ISSUE DATE: _____ PERMIT- HOOT H-600 BNR P 531090

**ON-SITE SEWAGE DISPOSAL SYSTEM
HOWARD COUNTY HEALTH DEPARTMENT
BUREAU OF ENVIRONMENTAL HEALTH**

ADDRESS: 3250 Roscommon Drive PROPERTY OWNER: Glenda Owen
Mike Owen

HOOT SYSTEM BNR H-600 CAPACITY (GALLONS): 600gpd **Top Seamed Three Compartment Tank including Pump Tank**

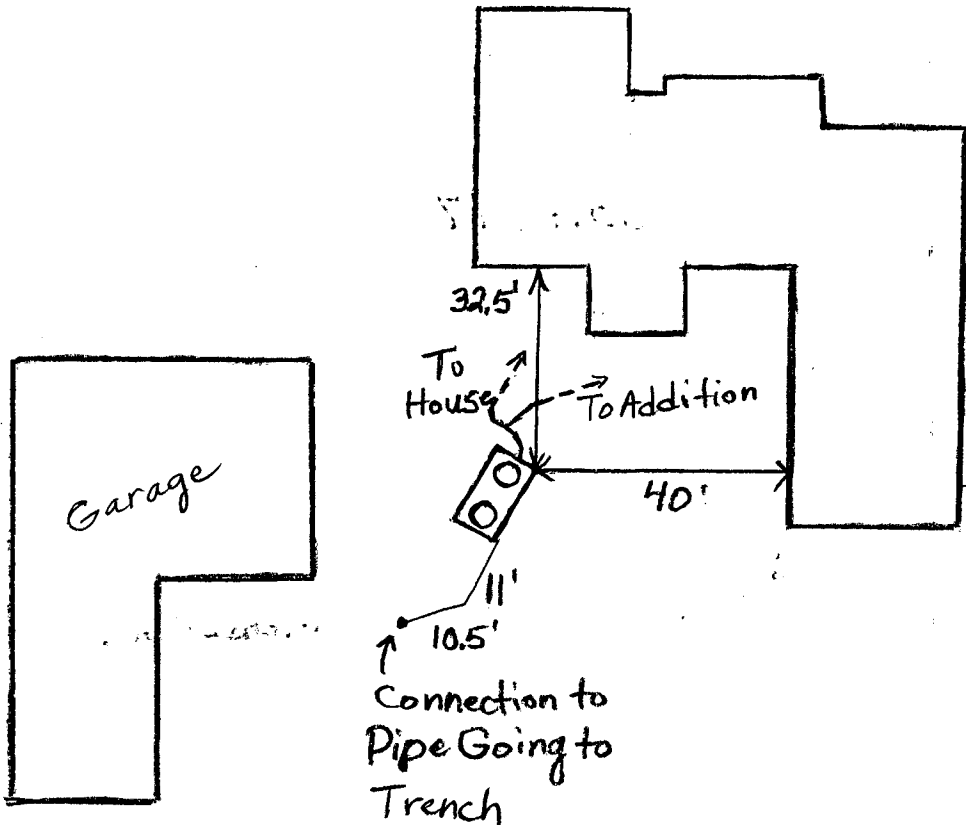
LOCATION:	Existing tank must be pumped and collapsed. Installation of new 'Hoot' System tank should be kept 100' from existing well or no closer than existing tanks.
-----------	---

NOTES:	A test of the blower, alarm, sensors in pump chamber, and the unit itself is required. Install Hoot system unit per manufacturer's instructions. A variance was approved to allow the tank depth to be a maximum of 5' deep.
--------	--

PRE-CONSTRUCTION: 7/27/09 Set Hoot tank near existing tank but no closer to the well or house. Tank was granted variance to be 5' deep. (BB)

INSTALLATION: 7/27/09 Dry well pumped out and filled with dirt. Old tank pumped out and filled with dirt. Hoot tank set and connected to house and addition. Pump line run from tank to pipe going to trench. Need start-up of Hoot system. (BB)
 7/28/09 Hoot system appears to be working. Need certification from installer and should put gravel under pipe where it comes out of tank. (BB) 8/5/09 Received start-up certification from Mayer Brothers. (BB)

Note: * Certification start – up letter from manufacturer needs to be sent into Health Depart. Prior to septic system approval. *****

DATE	JOB NUMBER	JOB NAME :	DESIGNED FOR	DESCRIPTION
03/31/09	0908013		MAYER BROS. INC	HOOT - NON-TRAFFIC

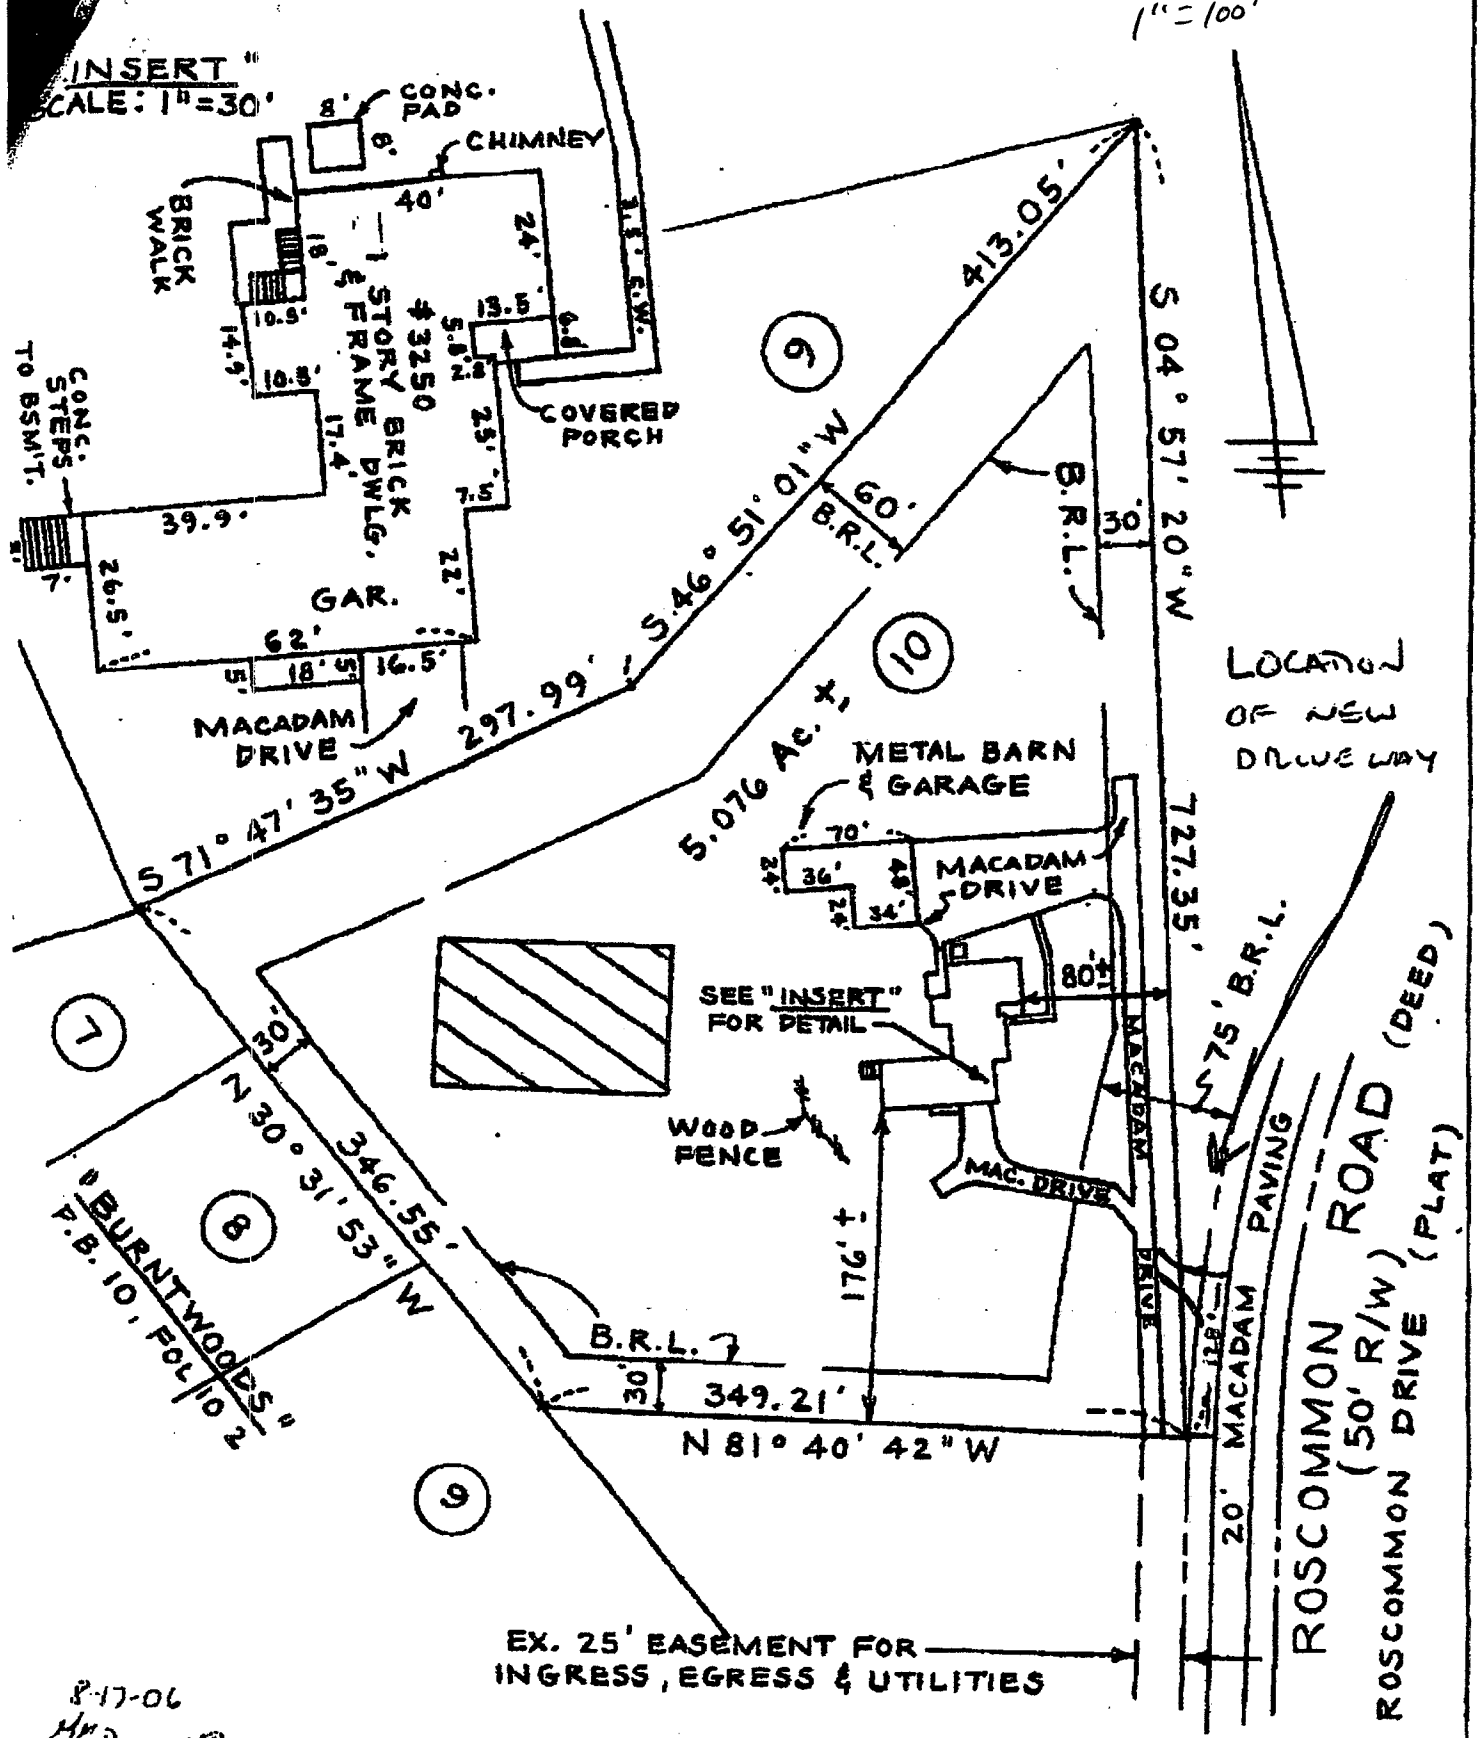
We are requesting a variance that will allow us to install the new Hoot 600 BNR system at the current tank depth of five feet instead of the recommended three foot depth.

Please see the attached specification sheet from Mayer Bros., Inc showing that the unit to be installed is approved for five feet of ground cover.

CONCRETE STRENGTH = 5000 PSI AT 28 DAYS
 NUMBER OF CELLS = 3
 LENGTH OF CELLS IN FEET = 2.40, 5.58, 4.10
 INSIDE WIDTH OF BOX IN FEET = 5.54
 INSIDE DEPTH OF BOX IN FEET = 5.17
 ASSUMED WEIGHT OF EARTH = 120 LB/CF
 SET EQUIVALENT LIQUID PRESSURE = 42.0
 HEIGHT OF FILL OVER BOX IN FEET = 5.00 MAX.
 THICKNESS OF TOP SLAB IN INCHES = 4.0
 THICKNESS OF BASE SLAB IN INCHES = 4.0
 PROJECTION OF BASE SLAB IN INCHES = 0.0
 SIDE WALL THICKNESS IN INCHES = 4.0
 END WALL THICKNESS IN INCHES = 4.0
 COVER FOR TOP SLAB INCHES = 2.0
 COVER FOR BASE SLAB INCHES = 2
 COVER SIDE WALLS INCHES = 2
 COVER FOR END WALLS INCHES = 2
 LOADING ON STRUCTURE = NON-TRAFFIC
 SURCHARGE ADDED IN FEET = 0.00 **5 Feet**
